Tender – Street Rehabilitation – Eastern Gateway Phase 2

Addendum # 3 Issued – January 26, 2024

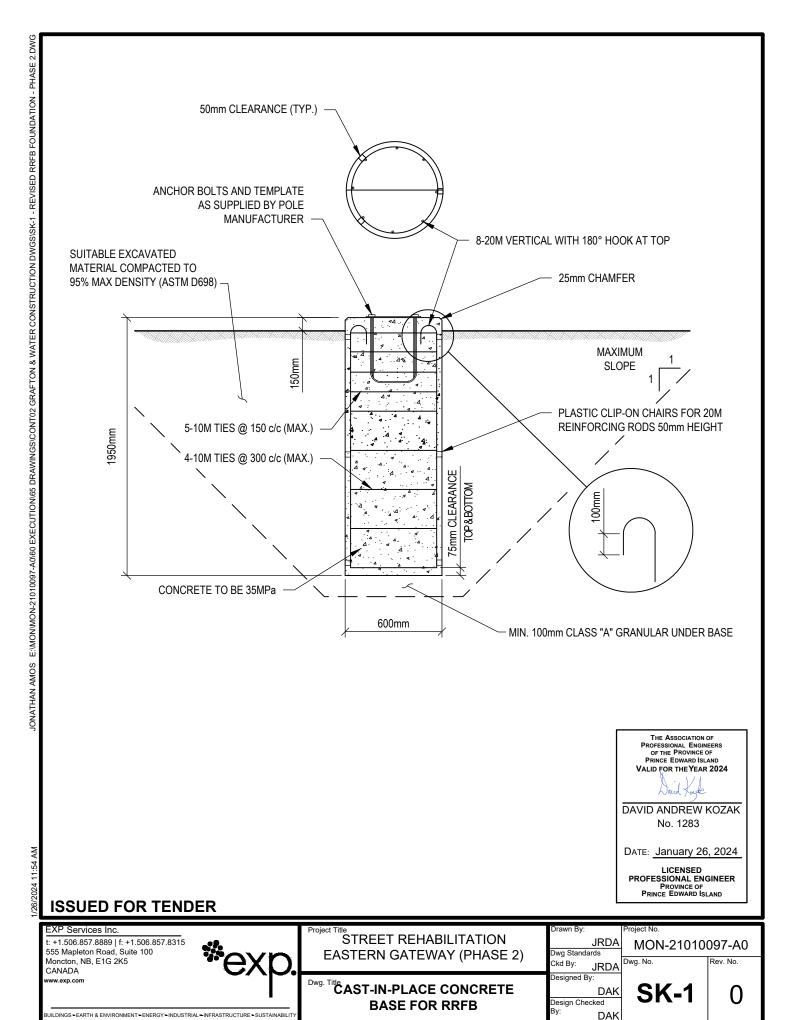
- 1. The attached sketch (SK-1) replaces the "Cast-In-Place Concrete Pole Base for RRFB" detail shown on Drawing No. 4-1.
- 2. The attached sketch (SK-2) replaces the "Street Light Concrete Base" detail shown on Drawing No. 10-4.
- 3. In Section 33 41 00 Storm Sewer, replace clause 2.3 with the following:
 - 2.3 HDPE PIPE (up to 900mm diameter only)
 - .1 Double walled HDPE pipe with smooth walled interior and corrugated exterior to 320 kPa to CSA B182.6.
 - .1 Locked-in flexible rubber gasket and integral bell and spigot system.
 - .2 Connect to catchbasins with PVC manhole adaptor.
 - .3 Acceptable products: Solflo Max by Soleno, Boss 2000 by Armtec and N-12 ST by ADS.
